STAFF REPORT 7/24/2019 MEETING  
APPLICATION NUMBER 19-6330  
ADDRESS: 479 W. WILLIS  
HISTORIC DISTRICT: WILLIS SELDEN  
APPLICANT: THOMAS ROBERTS

PREPARED BY: J. ROSS

# HISTORIC DISTRICT COMMISSION PROJECT REVIEW REQUEST

**Urbane on Willis**  
479 W. Willis  
Detroit, Michigan 48201

**A101**  
sheet number

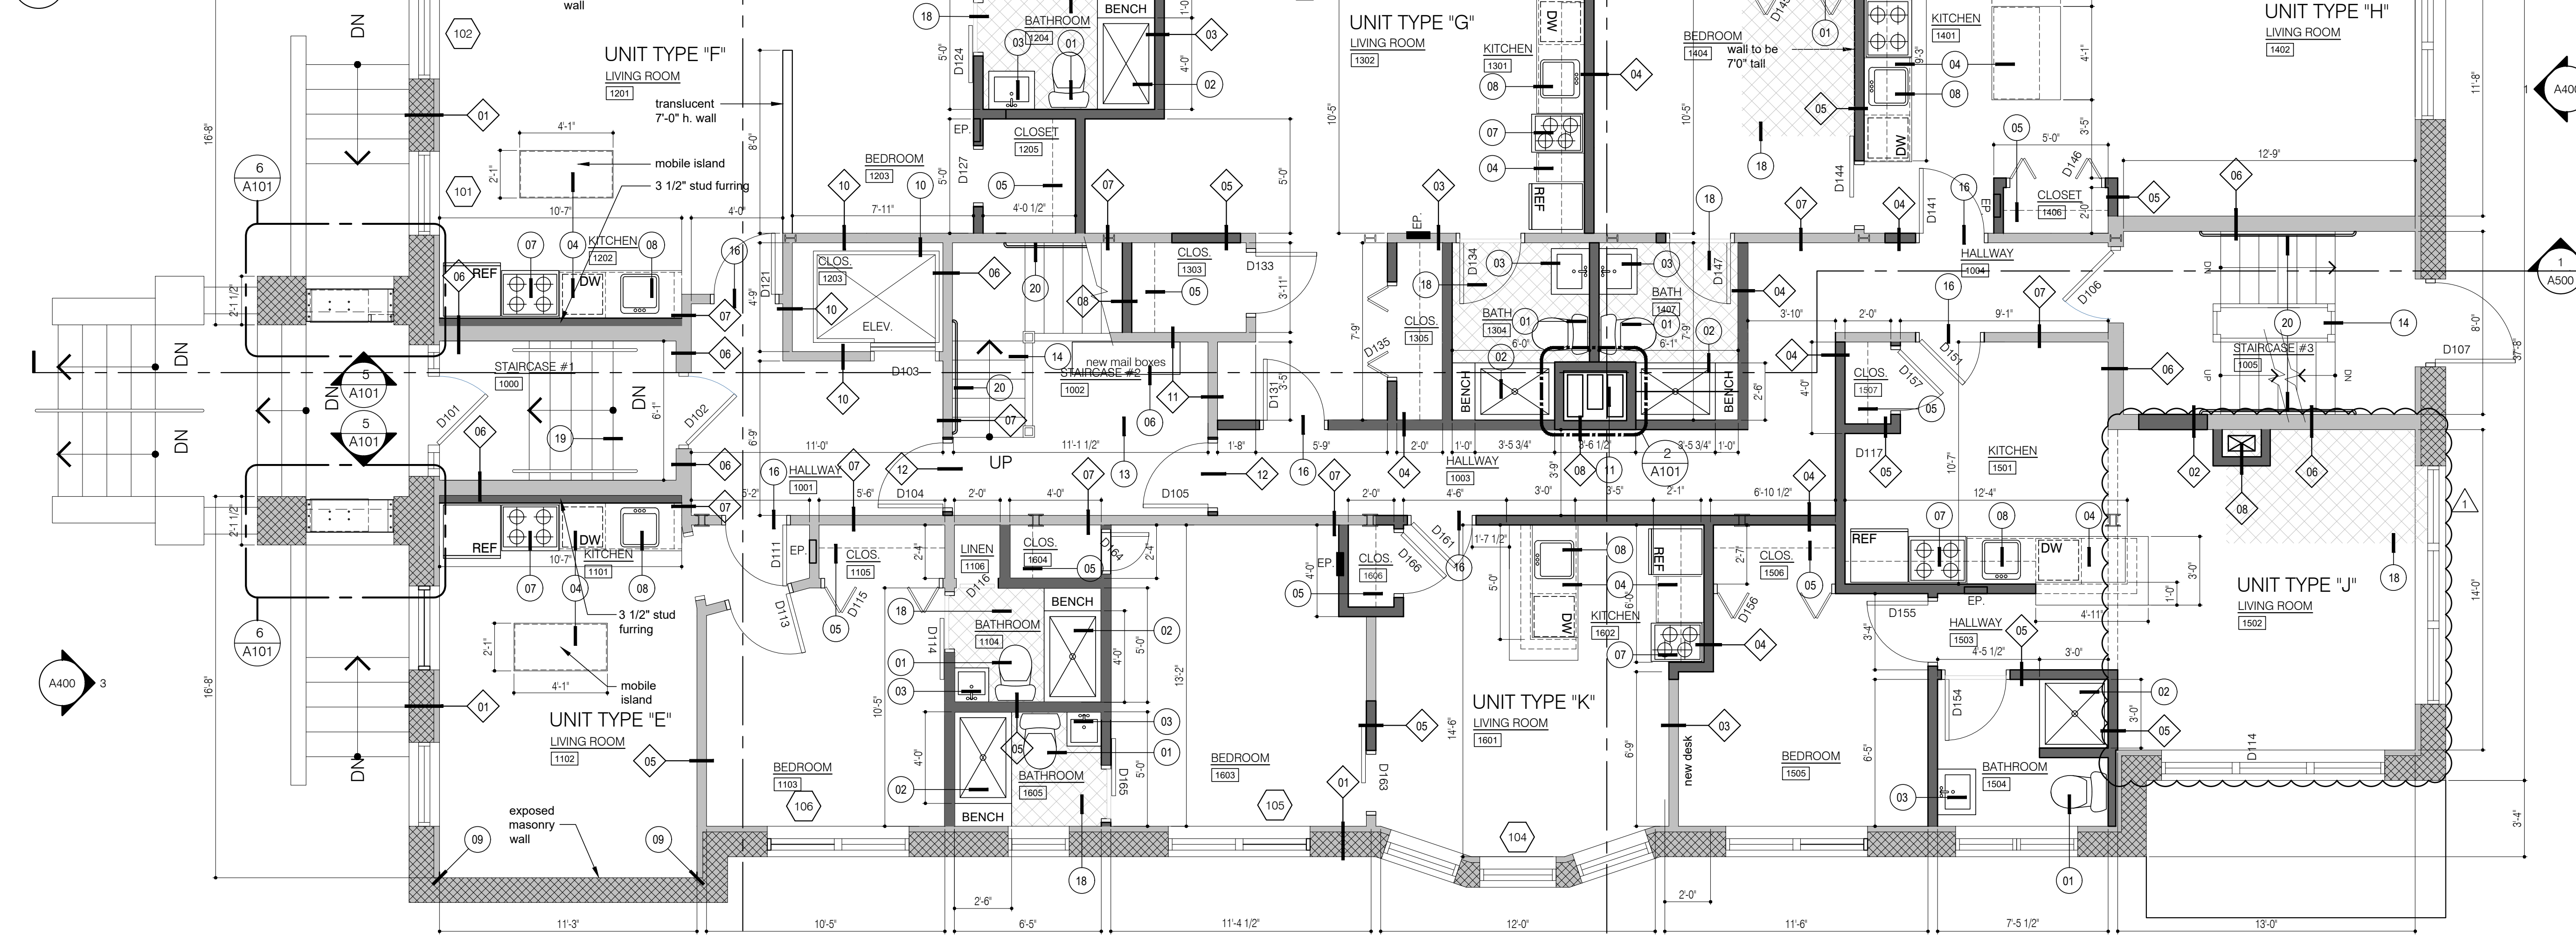
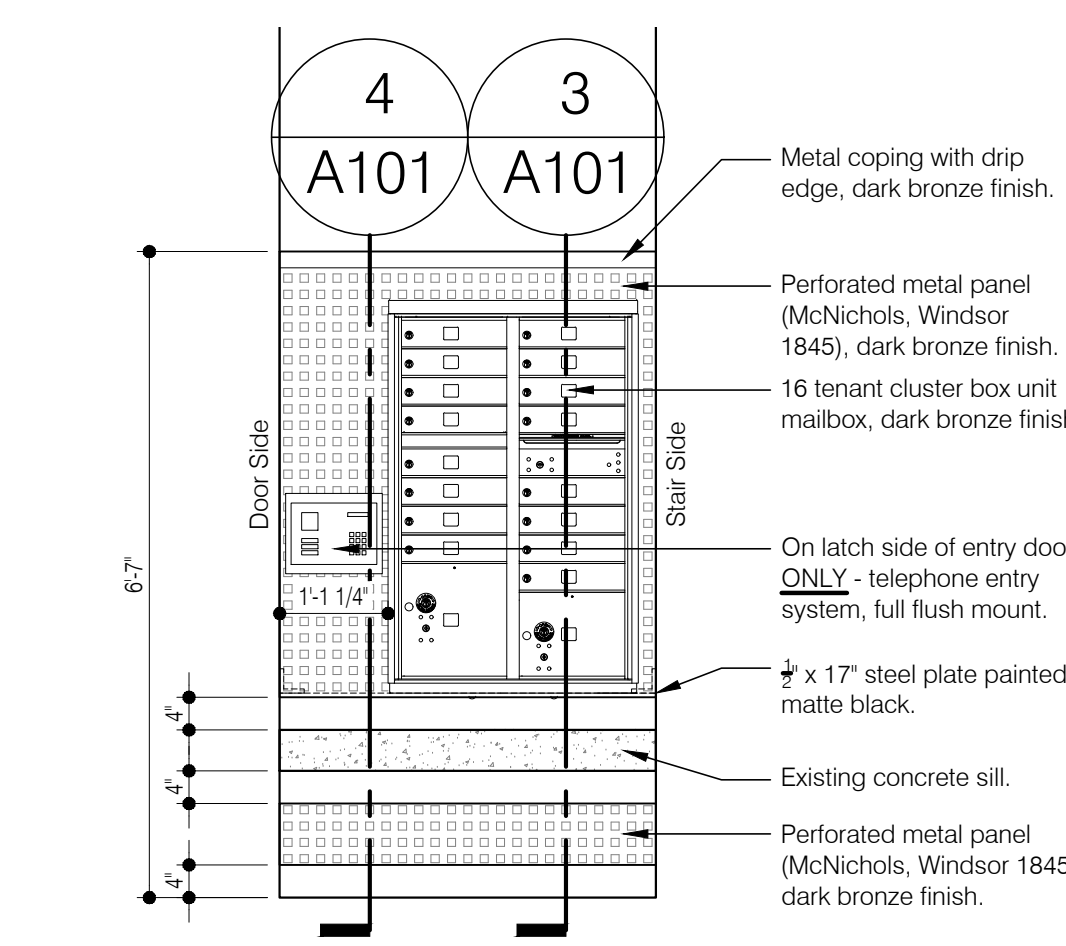
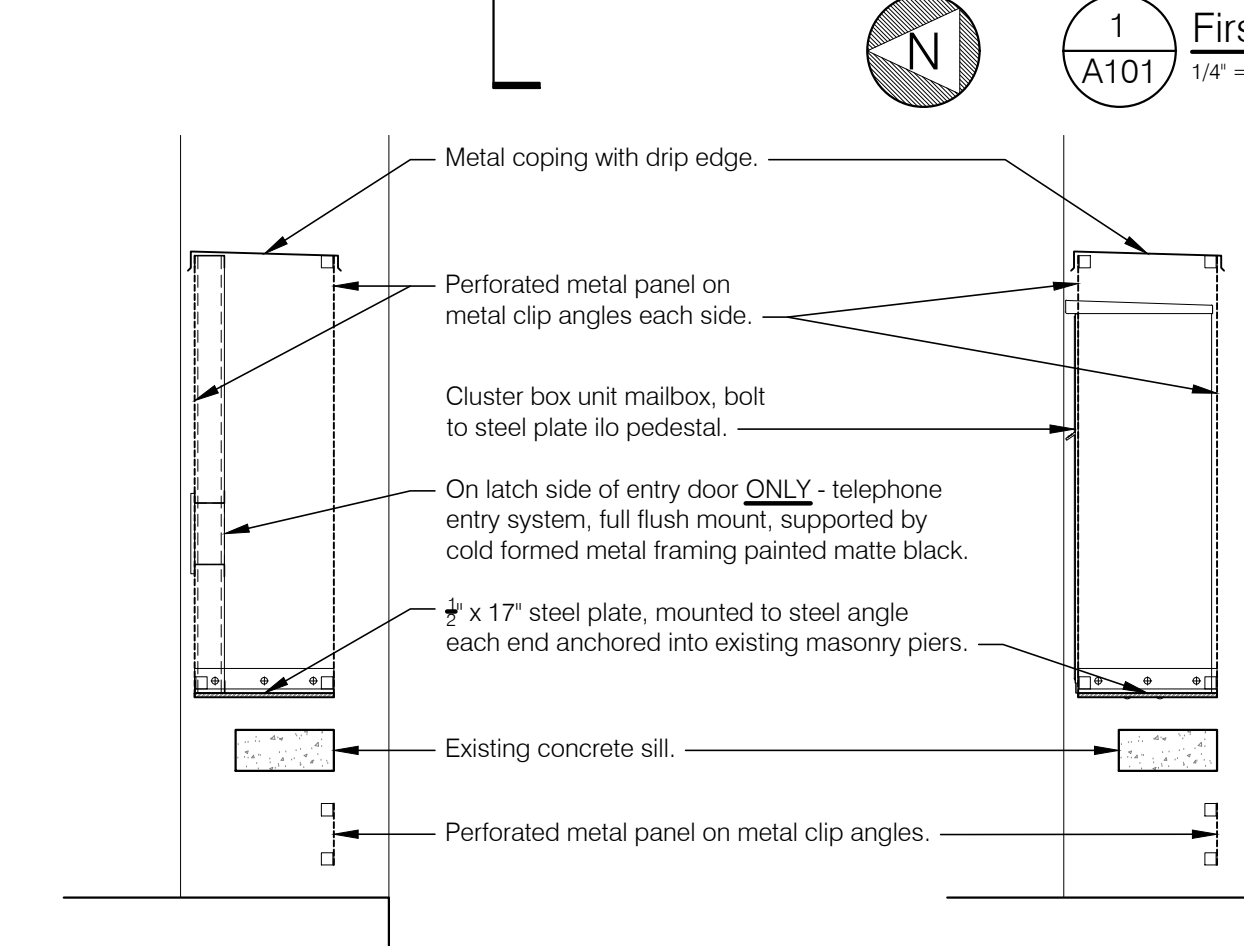
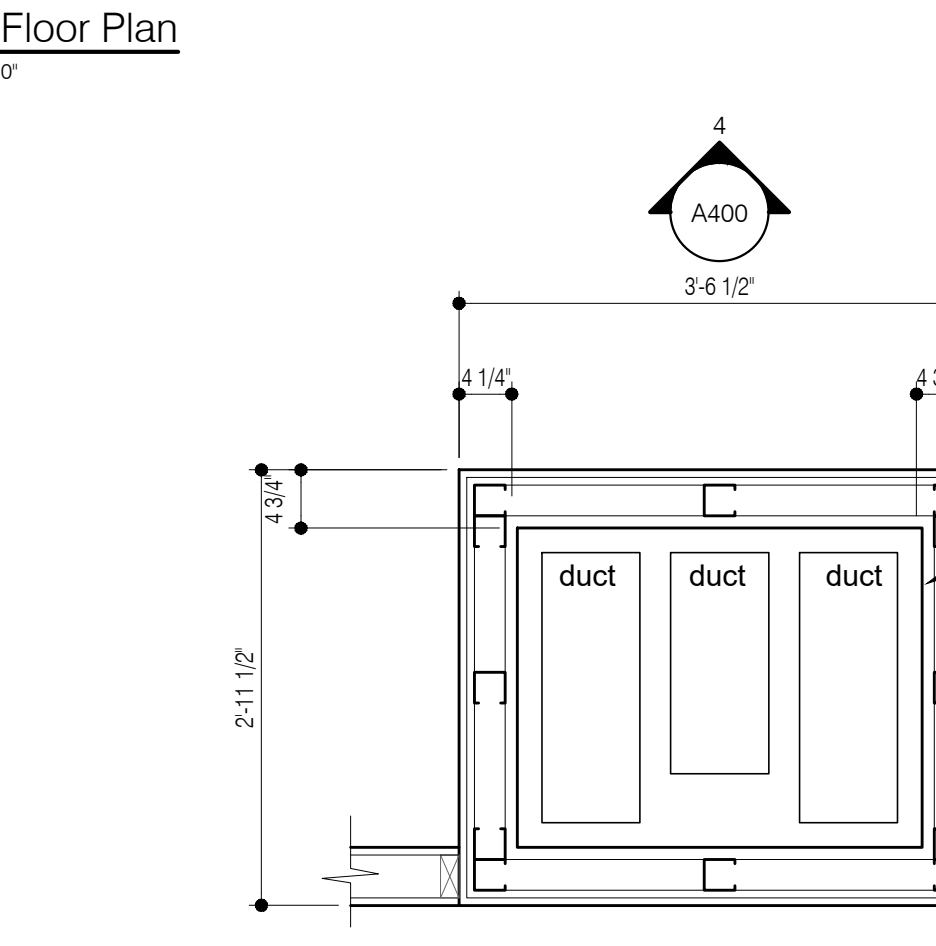
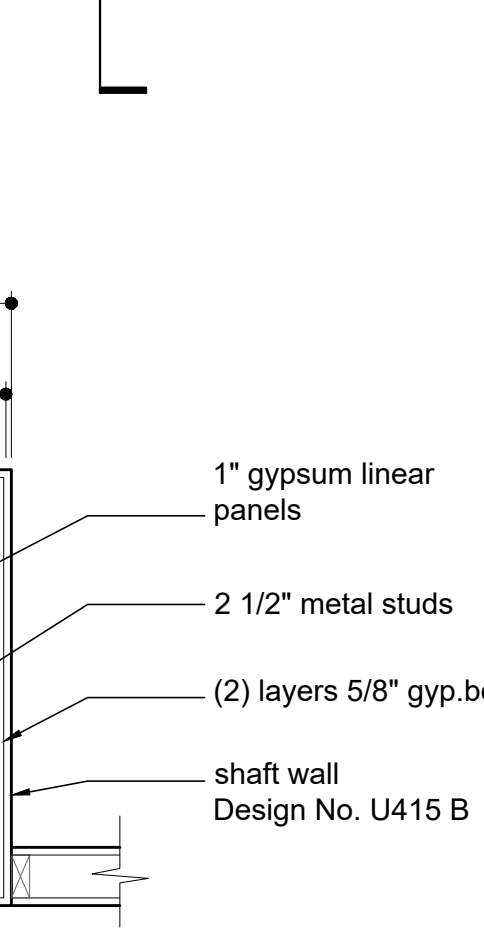
- The proposed new mailboxes will be highly visible from the public right-of-way when viewing the building's primary elevation at an oblique angle.
- The applicant has noted that he desires to locate the mailboxes/intercom on the porch (rather than installing the mailboxes in the front yard area/detached from the building) because the equipment will "...provide fall protection for the open stairs below each side of the entry porch."

It is staff's opinion that the front porch is a highly-visible, distinctive feature of the building. Although the work is reversible, it is staff's opinion that the proposed equipment/enclosure of the porch openings will negatively impact its historic character. More appropriate balustrades and railings could be proposed to meet code requirement for fall protection.

As noted previously, it is staff's opinion that the front porch is a highly-visible, distinctive feature of the building. Although the work is reversible, it is staff's opinion that the proposed location of the equipment /enclosure of the porch openings will negatively impact its historic character, subject to the conditions below. Staff recommends that the Commission approve the installation of new mailboxes and intercom at the property because it meets the Secretary of the Interior's Standard for Rehabilitation Standard Number 6. *Deteriorated historic features shall be repaired rather than replaced. Where the severity of deterioration requires replacement of a distinctive feature, the new feature shall match the old in design, color, texture, and other visual qualities and, where possible, materials. Replacement of missing features shall be substantiated by documentary, physical, or pictorial evidence.* However, staff does recommend that the Certificate of Appropriateness be issued with the following conditions:

- The new mailboxes shall be detached from the building and located/sited in the front yard area. The applicant shall provide a site plan and final proposal for the location of the mailboxes within the front yard area to HDC staff for review and approval prior to the issuance of the permit. If HDC staff determines that proposed location does not conform to the Secretary of the Interior's Standards for Rehabilitation and/or the Elements of Design, she shall forward the application to the Commission for review at a monthly meeting.

- The 6-7/16"(H) x 10-3/8"(W) x 3-1/2"(D) intercom may be installed separately from the mailbox/clusterbox units, surface-mounted, at the front elevation of the building. The applicant shall provide a dimensioned drawing which depict the location of the intercom to HDC staff for review and approval prior to the issuance of the permit. If HDC staff determines that proposed intercom installation does not conform to the Secretary of the Interior's Standards for Rehabilitation and/or the Elements of Design, she shall forward the application to the Commission for review at a monthly meeting.
